TECHNICAL EVALUATION REPORT ON THE
ADEQUACY OF STATION ELECTRIC DISTRIBUTION
SYSTEM VOLTAGES FOR THE
TURKEY POINT NUCLEAR GENERATING PLANT
UNITS 3 AND 4

(Docket Nos. 50-250, 50-251)

August 8, 1982

FIGURE 1 TURKEY POINT UNITS 3 AND 4 ELECTRICAL ONE-LINE DIAGRAM

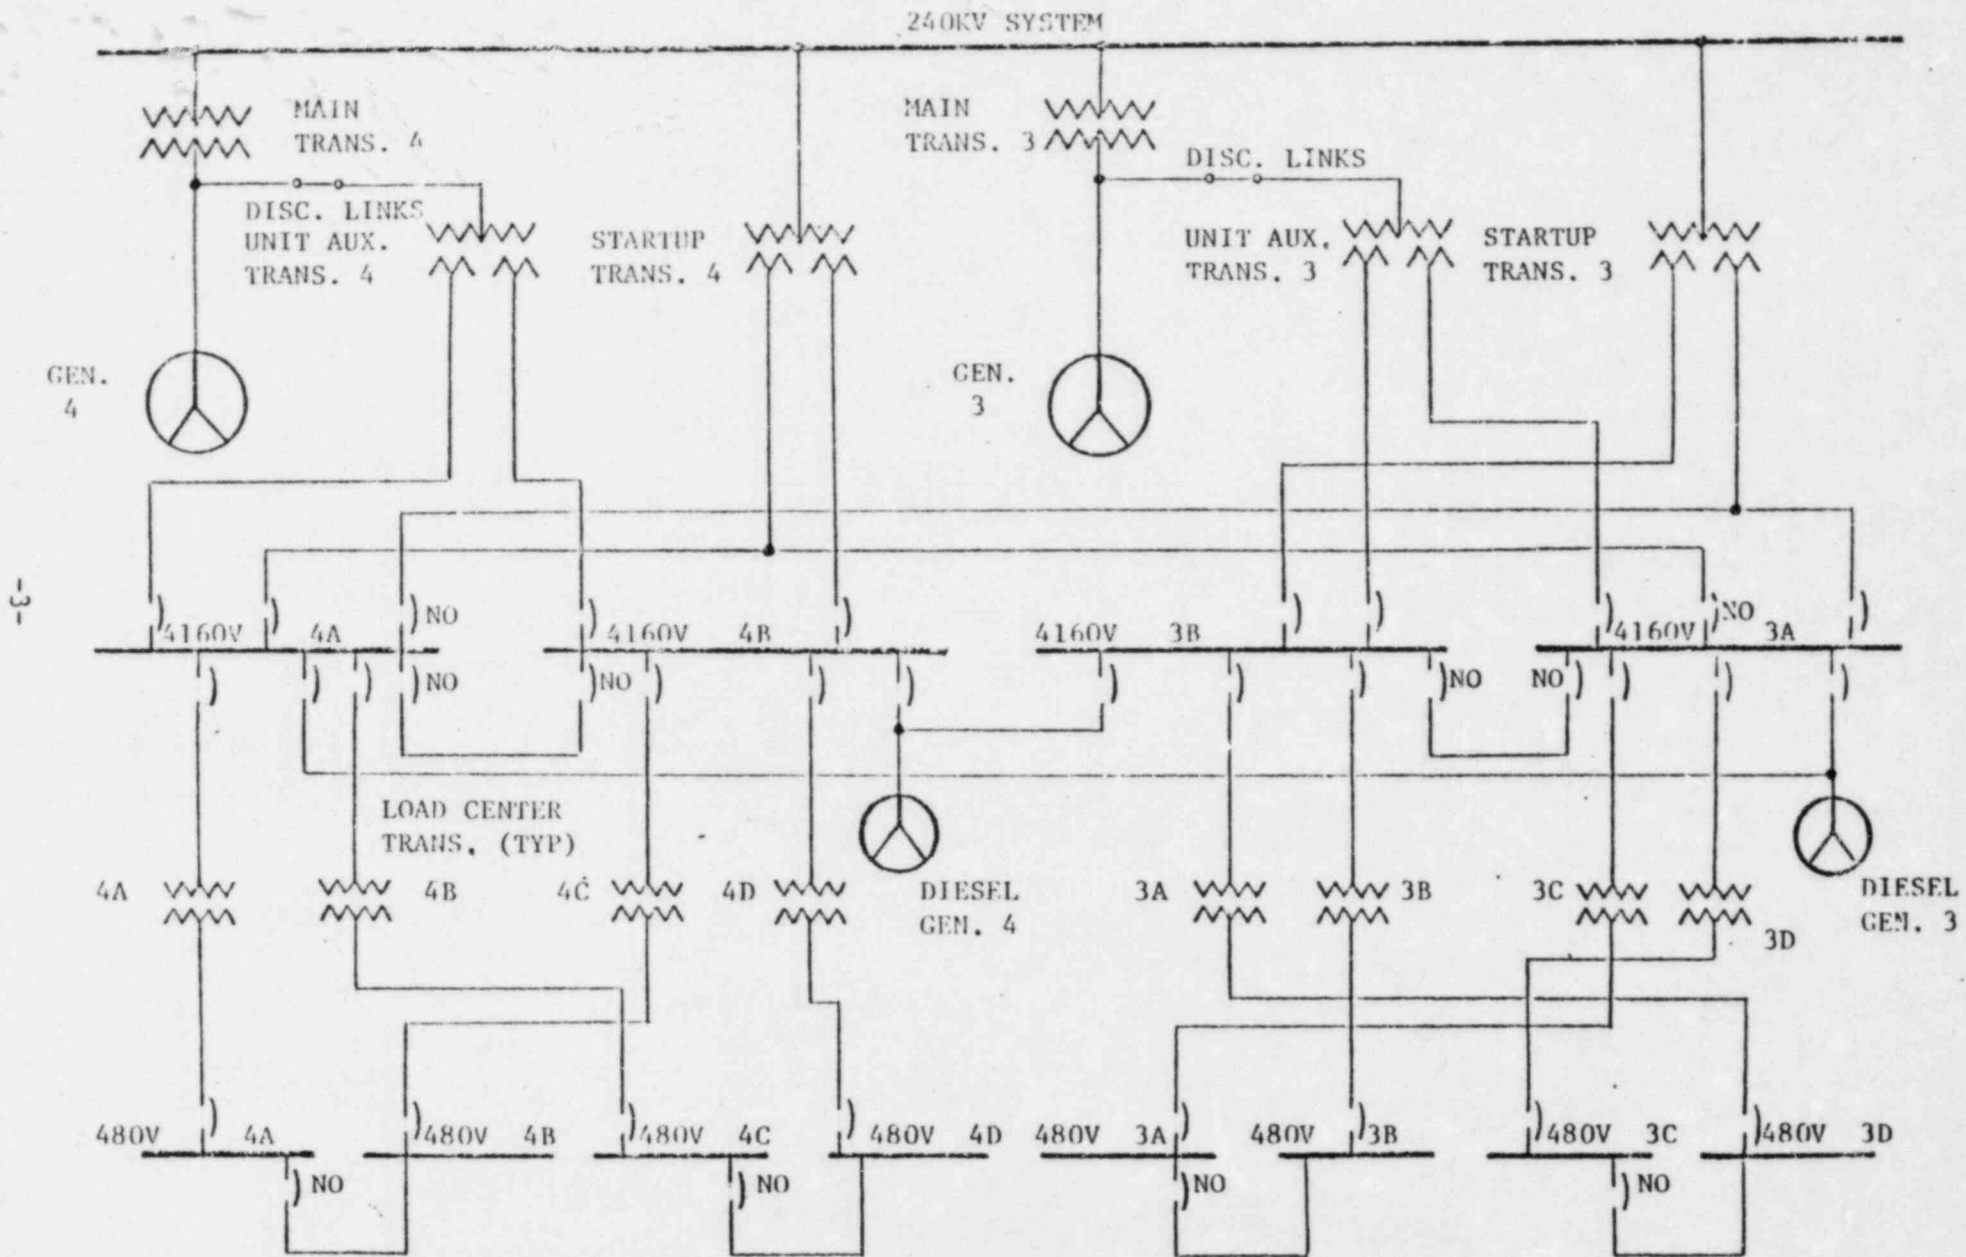
The sharing of an offsite source is via the adjacent unit's startup transformer. This condition only occurs when one unit is shutdown. Manual actions are required to align this connection. This connection only allows for one train of each unit (the A buses) to be supplied by the adjacent unit's startup transformer. Should a safety injection occur during this connection, the Class 1E equipment would automatically be started. Due to the greatly reduced load (i.e. one unit is shutdown) for this condition, the voltages being supplied by the adjacent startup transformer would be more adequate than the worst case analyzed voltages presented in the tables. Therefore, the shared offsite source (startup transformer) has the capacity and capability of supplying adequate voltage to both unit's Class 1E equipment.
